MONTGOMERY AUTO SALES PARK LOT 7 SITE PLAN AMENDMENT NO. 81995038A

Description

Request to add 2,036 square feet of gross floor area to accommodate four new vehicle service bays at an existing automobile dealership.

No. 81995038A Completed: 1-12-2024 MCPB 1-25-2024 Montgomery County Planning Board 2425 Reedie Drive, Floor 14 Wheaton, MD 20902

Figure 4 - Proposed Amended Site Plan

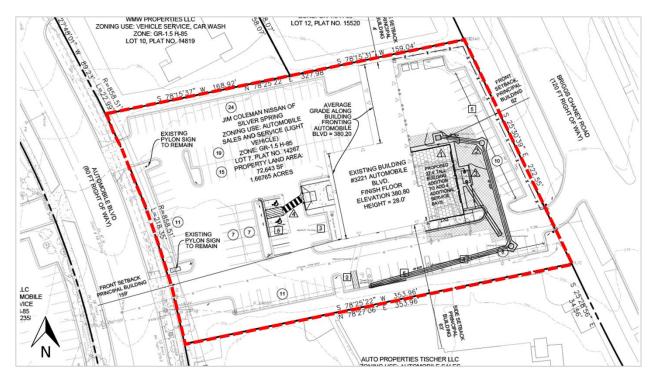
As shown on the Site Plan, parking, queuing and loading areas are adequate to serve the site. As shown in Table 1, parking spaces are adequate and meets all zoning requirements. As noted above, the Project is a minor expansion to the rear of the existing building and does not substantially alter the existing parking, queuing and loading spaces.

The required number of parking spaces for the 2,036 square feet expansion equals three (3) minimum and six (6) maximum parking spaces. Pursuant to Sec. 6.2.9.A.1, the expansion is exempt from parking lot landscaping because the number of spaces for the expansion equals fewer than 10 spaces. Pursuant to Sec. 6.2.3, motorcycle/scooter parking spaces, car-share spaces, spaces for charging electric vehicles are not required because the number of required parking spaces for the expansion is fewer than 50 spaces. Pursuant to Sec. 59.6.2.4.C, bicycle parking spaces are not required for Light Vehicles Sales (Outdoor) uses. There are no alterations to the existing development that change the parking standards for the existing development. However, pursuant to Sec. 7.7.1.B.3.b, the previously approved parking requirements for the existing development are amended and reduced in a manner that satisfies Sec. 6.2.3 (Calculation of Required Parking) and Sec. 6.2.4 (Parking Requirements). This provision allows for a reduction in the minimum number of parking spaces for the existing development while maintaining conformance with the 2004 Zoning Ordinance.

Figure 7 - Proposed Landscape Plan

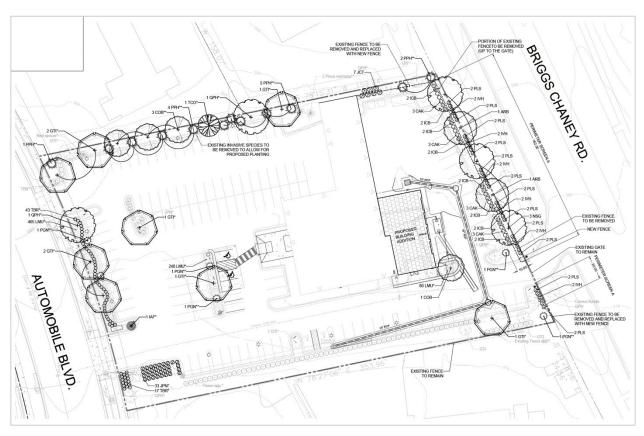
As shown on the landscape plan (Figure 7), the Project satisfies the requirements of Division 6.4. The Master Plan recommends the provision of additional trees along Briggs Chaney Road, which this Application provides as shown in the landscape plan. The proposed row of shade trees along Briggs Chaney Road will enhance the pedestrian experience, provide additional shade, and create an aesthetically pleasing presence along the roadway.

The Project will amend the landscape plan to provide additional screening and replace some missing trees and landscape within the parking areas and along property lines. The open spaces, landscaping, and site details adequately and efficiently meet the needs of the use and the recommendations of the Master Plan, while providing a safe and comfortable environment.

*** Addition to an existing building ***

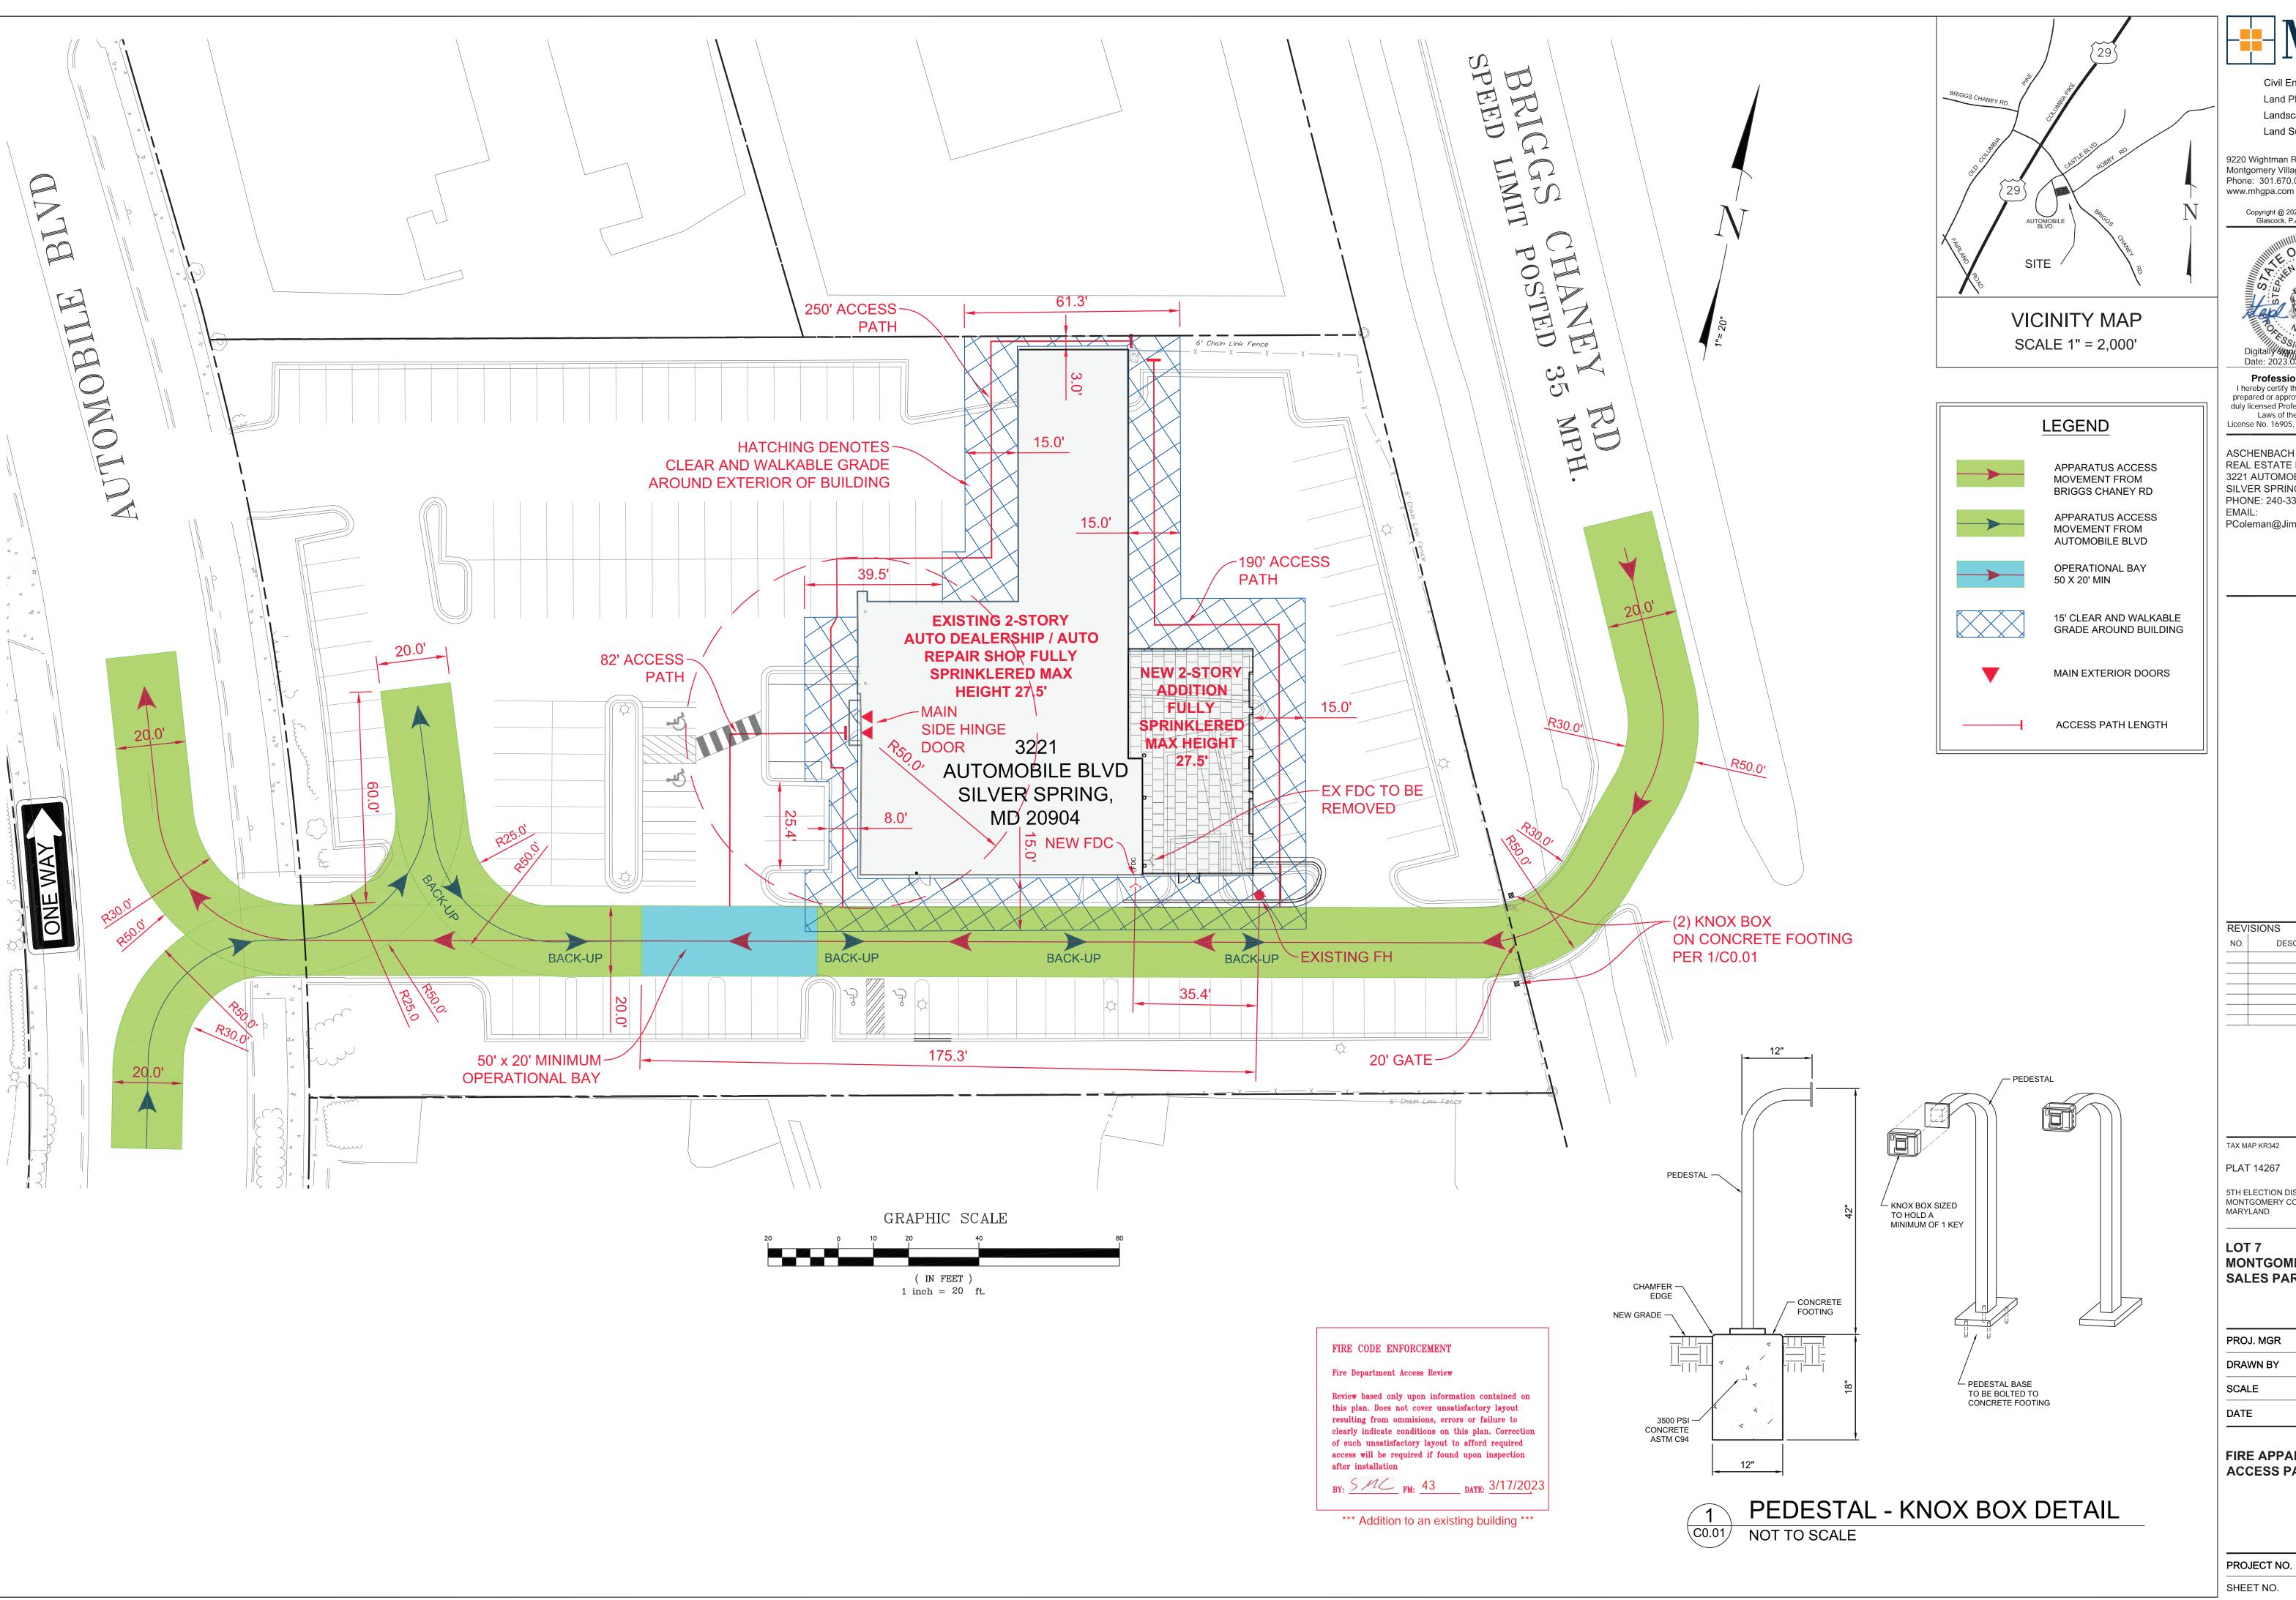
The development at ultimate conditions will provide 15' of clear and walkable grade around the building. However, on the North side of the existing building there is only 3' of distance from the building to the property line, thus reducing the clear and walkable grade to 3' for 61'. On the Northwest portion of the existing building, the clear and walkable grade has a 39' break in it where existing parking spaces are located which restricts access to between the parked cars. In the front of the building three parking spaces reduce the clear and walkable grade width to 8' for 25'. These are all existing non-compliant conditions that are not being exacerbated by the proposed development.

Review based only upon information contained on this plan. Does not cover unsatisfactory layout resulting from ommisions, errors or failure to clearly indicate conditions on this plan. Correction of such unsatisfactory layout to afford required access will be required if found upon inspection after installation
